Access Compliance Report

Public Rights-of-Way

Intersection ID: 3874	Main Street: GARRISON_RD	Cross Street: MARBLE_HILL_DR	Location: W
ADA ID: 3F5B024E2483	Ramp Type: PerpDiag	Initial Pass/Fail: Fail	Overall Compliance: No
		Severity Score: 30

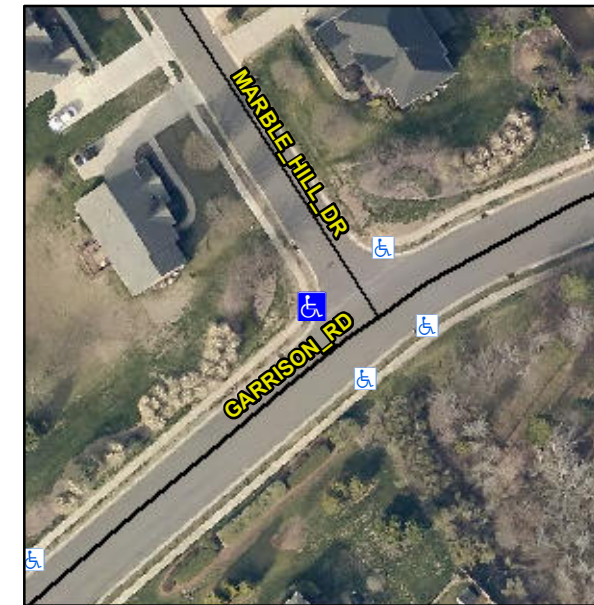
Not Found, R304.5.1, R304.2.2

Compliance	Description	Data	Compliance	Description	Data
N/A	Ramp Length (in)	46.5	No	Ramp Slope (%)	8.5
No	Ramp Width (in)	35.0	Yes	Ramp XSlope (%)	1.8
N/A	Flare Type LT	N/A	N/A	Flare Type RT	N/A
N/A	Flare Slope LT (%)	N/A	N/A	Flare Slope RT (%)	N/A
N/A	Flare Traversable LT?	N/A	N/A	Flare Traversable RT?	N/A
N/A	Landing Length (in)	N/A	N/A	DWS Provided?	N/A
N/A	Landing Width (in)	N/A	N/A	DWS Contrast?	N/A
N/A	Landing Slope (%)	N/A	N/A	DWS Length (in)	N/A
N/A	Landing X Slope (%)	N/A	N/A	DWS Full Width?	N/A
N/A	Landing Curb? (Y/N)	N/A	N/A	DWS Offset (in)	N/A
N/A	Shared Landing?	N/A			
N/A	Gutter Ponding?	N/A	N/A	Gutter Slope (%)	N/A
N/A	Gutter Lip Ht (in)	N/A	N/A	Gutter X Slope (%)	N/A
N/A	Painted X Walk1?	No	N/A	Painted X Walk2?	No
	X Walk 1 Direction	To SE		X Walk 2 Direction	To NE
N/A	X Walk 1 Width (in)	N/A	N/A	X Walk 2 Width (in)	N/A
	X Walk 1 Slope (%)	1.8		X Walk 2 Slope (%)	1.2
	X Walk 1 X Slope (%)	0.9		X Walk 2 X Slope (%)	0.2

Remove & Replace Curb Ramp With Two New Directional Ramps or Equivalent.
